Mini **Model year from 12.2001 to 03.2004** **All vehicles with seat heating**

Seat heating does not work correctly

Fig. 1

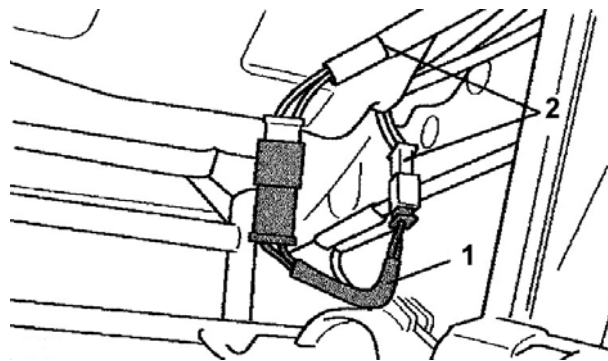
If there are complaints above the above-mentioned fault, the cause could be an incorrect heating element resistance. In this case, the customer may complain about excessively strong or weak warming from the seat heating. For both cases, special adapter harnesses (see Fig. 1, Item 1), which are inserted into the existing seat wiring harness (see Fig. 1, Item 2), are offered by the manufacturer. After installation, these are then fastened to the seat frame with the aid of cable clips (see Fig. 2, Item 3).
